14. DESIGN REVIEW PANEL

Summary of DRP Suggested Enhancements

STATION YARD DEVELOPMENT - SITE & CONTEXT

Station Yard, Twickenham

Ground Floor Plan Showing Entrances, Internal Circulation and Vertical Circulation

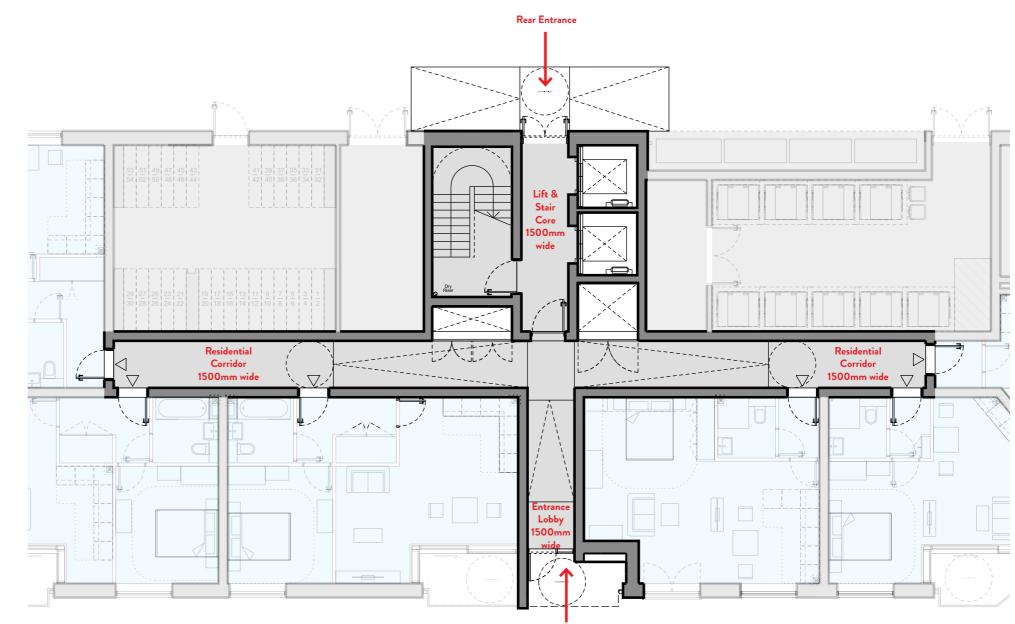
1. All Flats To Have Level Access From Street Level

It was recommended that the design team explore ways to make all ground floor flats accessible/Part M compliant, and preclude the need for future occupants to retrofit individual stair lifts by introducing ramps that provide level access to ground floor accommodation.

1. Level Access Provision

Previously, the ground floor flats were accessed via steps. In response to the DRP comments, a ramp system has been incorporated within the building circulation that is Part M compliant, rises up 600mm to the FFL of the ground level flats and removes any restrictions on access.

There is one main entrance for the residential units at the front (south) of the building, which opens into the lobby and corridor. There is also a rear entrance which opens straight into the stair and lift core and which is accessed from a ramp along the rear (north) of the site. Both entrances are level from the street, with ramped access rather than steps.

2. Roof Level Plan

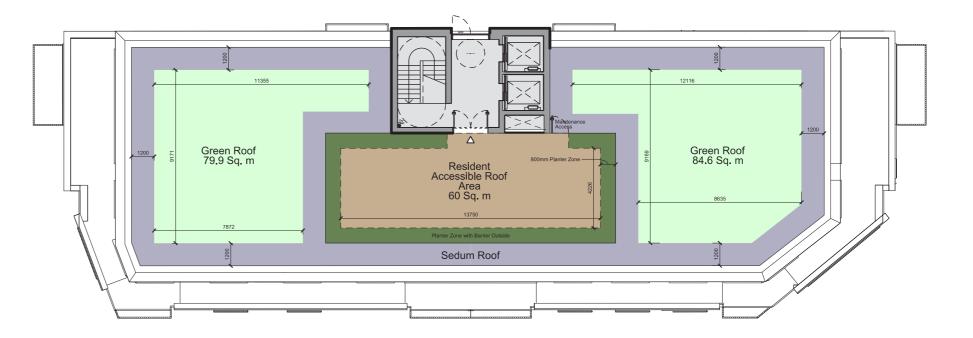
2. Consider Utilising The Roof As A **Residents Garden**

Given the restricted amount of green space around the building, the Team was encouraged to explore the introduction of green roofs. The rooftop offers opportunity to provide green amenity/garden space for the residents as well as forming a pleasant outlook from surrounding buildings.

Following on from the DRP suggestion that the roof could be used as accessible garden space, we explored the potential for a roof garden.

The roof garden is limited to 60 Sq. m or 1 Sq. m per person for a maximum 60 people, to comply with fire regulations.

The adjacent roof plan sketch indicates a decked area enclosed within planters with handrails or glass barriers to provide the 1100mm required. Access to the roof for maintenance is via a gate in the roof garden barrier.

Roof Garden Conclusion

Our opinion is that the proposal contradicts a Pre-app requirement that the proposals should be lower than Bridge House. The access requirements result in a lift and stair core that is increased in height and makes the building visibly taller than the adjacent Bridge House.

Height of development

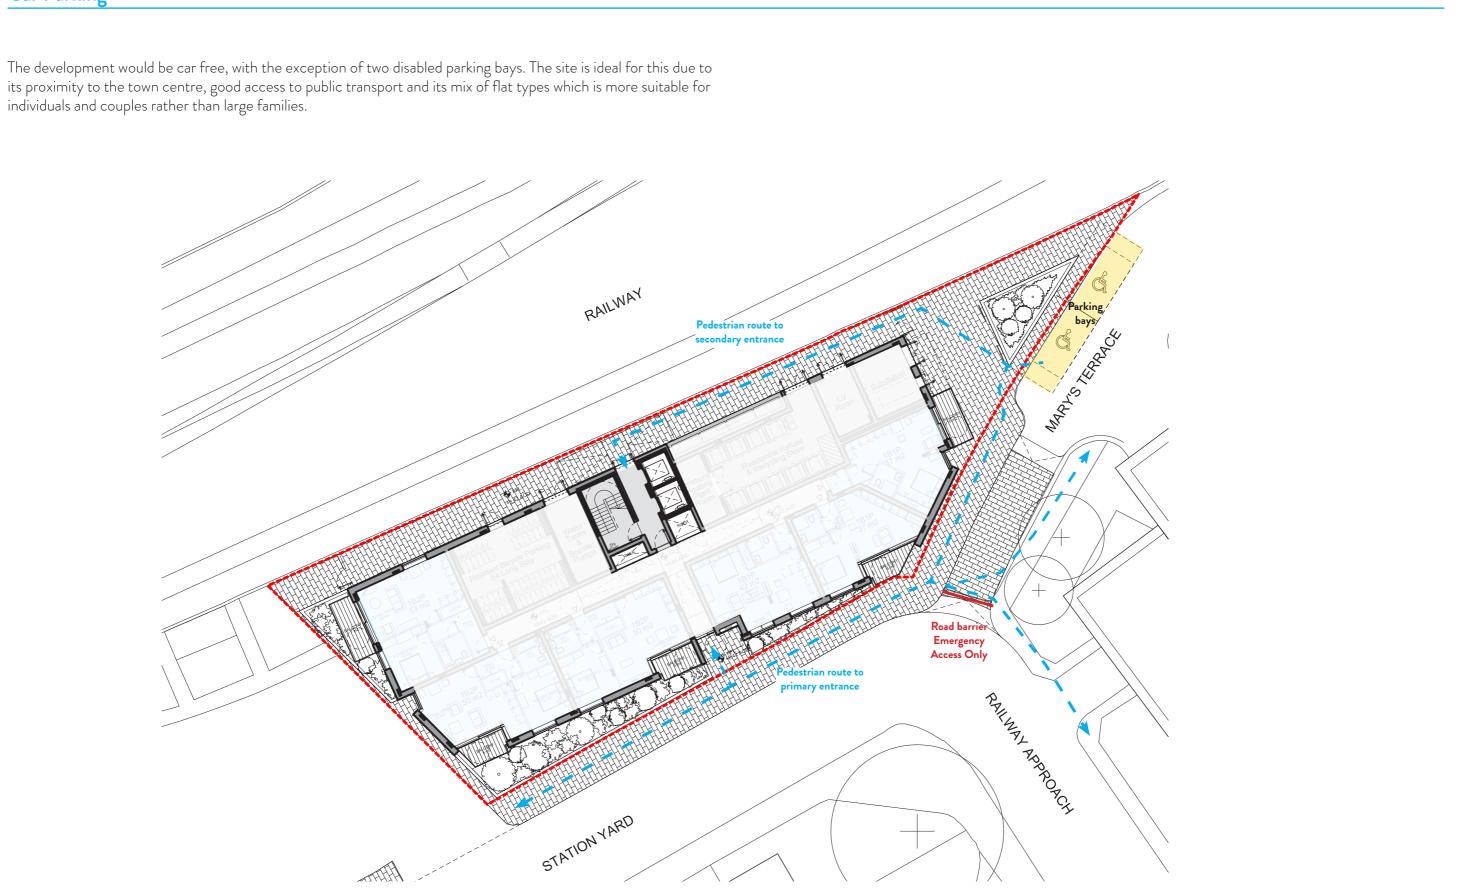
- The potential for a reduction in **parking** options which are already limited
- An increase in road **congestion** •
- The **height** of the development
- Improving the area, which is in need of development
- The potential for **affordable** housing
- **Car-free** development plans
- Public realm improvements, particularly tree planting

The proposal has been limited to a maximum height of Bridge House at 29.17m AOD, as discussed at Pre-App 1. The DRP indicated that they were very comfortable with the proposed height.
